Executive Director's Recommendation

Commission Meeting: October 2, 2014

PROJECT Dwight D. Eisenhower Memorial National Mall and Memorial Parks Bound by Independence Avenue, 4th Street, and 6th Streets, SW, and by the Lyndon B. Johnson - Department of Education Headquarters Building Washington, DC	NCPC FILE NUMBER 6694 NCPC MAP FILE NUMBER 1.71(73.10)44008 APPLICANT'S REQUEST Preliminary approval of site and building plans
SUBMITTED BY United States Department of the Interior National Park Service on behalf of the Dwight D. Eisenhower Memorial Commission	PROPOSED ACTION Approve with comments ACTION ITEM TYPE Staff Presentation
REVIEW AUTHORITY Approval per 40 U.S.C. 8903, 40 U.S.C. § 8905, 40 U.S.C. 8711(a), and 40 U.S.C. 8722(b)(1) and (d)

Figure 16: Plan for LBJ Promenade (showing security barrier line in red)

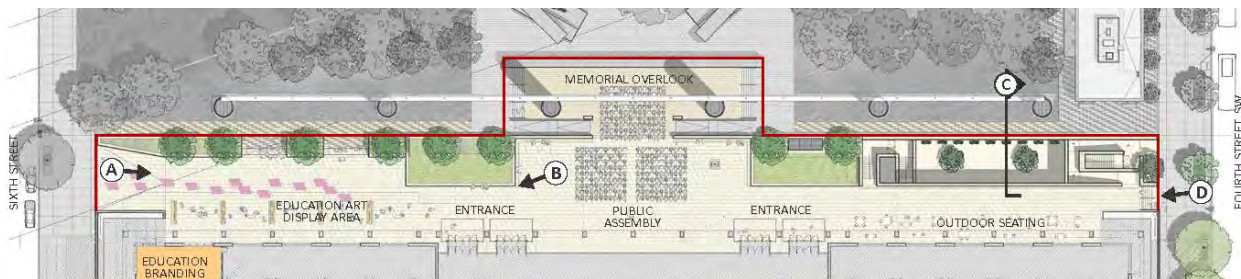
LBJ Promenade will also serve a security function, providing a 50-foot security buffer between the north façade of the LBJ Building and the memorial. Much of the security barrier has been integrated into the north retaining wall of the promenade. Bollards are proposed at the east and west ends of the promenade, across the stairways adjacent to the exhibit area, and at the base of the stairways and ramps leading from the overlook to the memorial core.

Previous staff reports raised questions regarding the absolute need for the proposed bollards, especially along the north side of the promenade given the elevation of LBJ Promenade, the distance from Independence Avenue, the placement of memorial elements, and the number of trees that will be planted on the site. In its April 2014 action, the Commission requested the applicant to work with staff to address the questions raised regarding the proposed physical perimeter security elements. No changes have been made to the design and placement of the proposed perimeter security elements since the Commission's April 2014 review. However, the applicant states that the design team has no objection to modifying the design but must work with GSA and the Department of Education to examine the feasibility of eliminating any proposed security elements. Following consultation with GSA and the Department of Education, the applicant will respond to the Commission's comment.

Figure 22: Comparison of previous and current preliminary memorial designs relative to the building line along Independence Avenue

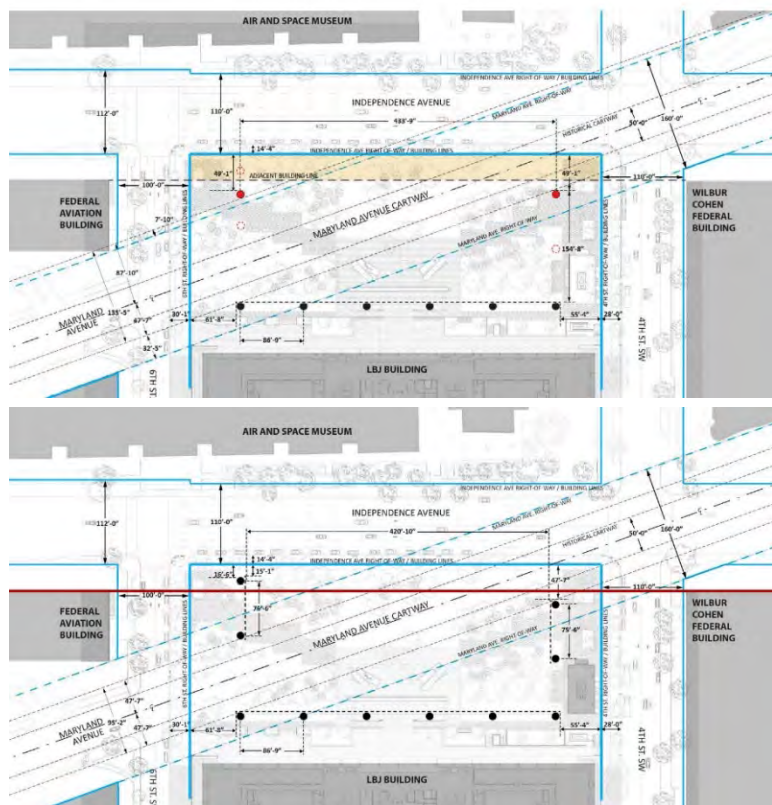
this design principle due to the previously proposed west tapestry extending beyond the building line established by the setbacks of the buildings to the east and west (Wilbur Cohen Building and Wilbur Wright Building), which resulted in a visual intrusion into the existing view along Independence Avenue, a primary approach to the memorial. The removal of the east and west tapestries and placement of the freestanding columns south of the aforementioned building line in the revised design resolves the visual intrusion along Independence Avenue (Figure 22). Staff finds the revised preliminary design consistent with this principles.
